**STATE OF MINNESOTA
BEFORE THE PUBLIC UTILITIES COMMISSION**

In the Matter of Xcel Energy's 2025
Integrated Distribution Plan

MPUC DOCKET NO. E-002/M-25-142

**INITIAL COMMENTS ON XCEL'S INTEGRATED DISTRIBUTION PLAN OF
ENVIRONMENTAL LAW & POLICY CENTER,
COOPERATIVE ENERGY FUTURES, AND VOTE SOLAR**

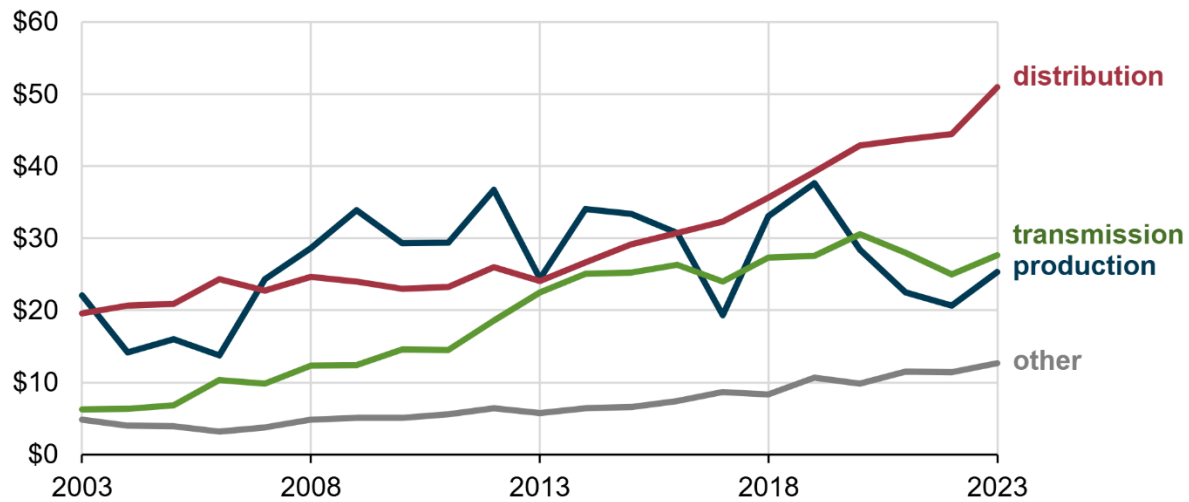
This reflects a dramatic increase over its prior actual spending in 2020-2024 of about \$436 million per year, with a total of just over \$2 billion.⁴⁷

In its Information Request No. 89 (Attachment 3), the Department further demonstrated the significant increase in spending on key categories, comparing average annual spending in 2020-21 to 2026-30, and showing a 291% increase in age-related spending, a 500% increase in capacity spending, and a 215% increase in reliability spending. Responding to the Department's request to explain these increases, Xcel offered relatively limited additional detail. The Company also indicated in the same IR response that it expects the budgets to grow in all three areas in the 2031-36 period.

The significant budget growth—and the Company's expectation that it will continue—demonstrate how distribution spending is squarely at the heart of affordability. Looking across the United States, as shown in the figure below from the U.S. Energy Information Administration (EIA), while generation and transmission costs in recent years are relatively flat, distribution costs are rising steeply.⁴⁸

**Figure 2-9
Project Timeline**

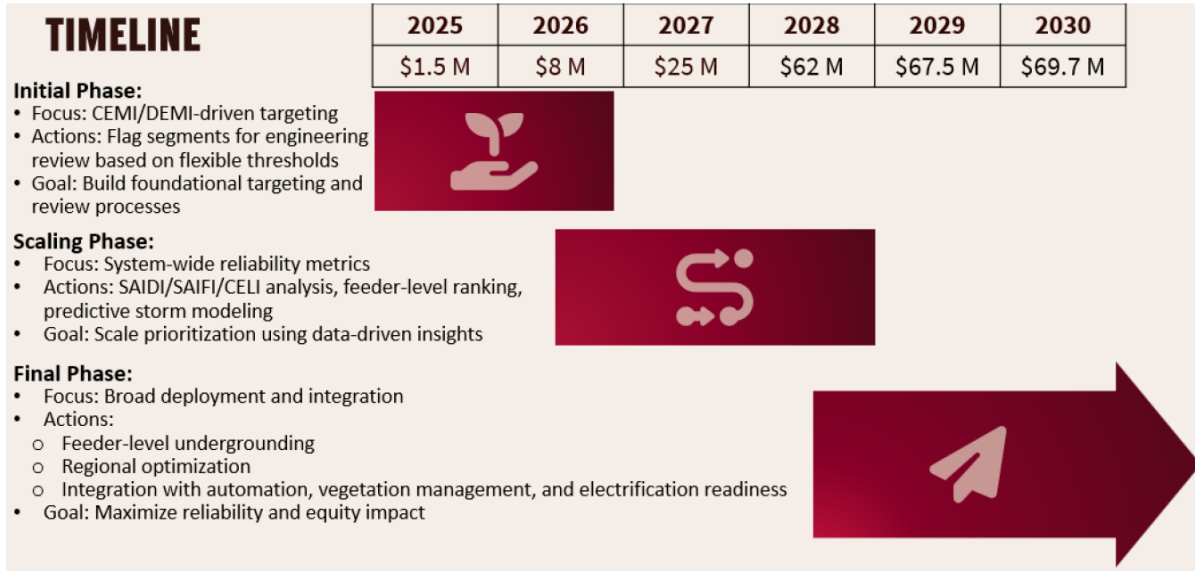
Company later similarly states: “To ensure equitable investment, the Company will incorporate findings from an independent third-party evaluation. This evaluation will inform demographic analysis to identify underserved or vulnerable communities, and community engagement strategies coordinated with local stakeholders and municipalities.”⁶⁵ However, Xcel provides no detail on what relevant findings it expects to get from the study, which ELPC/CEF/VS understand will examine the Company’s capital investment and other internal processes. Moreover, Xcel does not explain how or when it will integrate these findings or equity and demographic considerations in general into its targeted undergrounding plans and processes. Similarly, in IDP Figure 2-9 copied below, the Company identifies its focus on engineering review to drive targeted undergrounding projects in both its Initial and Scaling Phases.⁶⁶ Only in the Final Phase does the Company identify the goal to “maximize reliability and equity impact.” But the Company offers no explanation for when this Final Phase will occur or how it will maximize its equity impact.

Especially given the large budget proposed, ELPC/CEF/VS recommend that the Commission require Xcel to integrate equity considerations explicitly and transparently into its targeted underground program from the start to ensure that communities facing disparities in reliability appropriately benefit in a timely manner. In addition, as discussed further below in Section III.B.17 with respect to integrating equity considerations into planning more generally, we suggest that the Commission require the Company to explore using the Interruption Cost Estimate (ICE) 2.0 Calculator from Lawrence Berkeley National Laboratory to inform this integration. To the extent the ongoing third-party study provides additional insights, Xcel should incorporate those, as well; however there is no reason to delay consideration of equity when the Company has already identified disparities in reliability and targeted undergrounding as a solution.
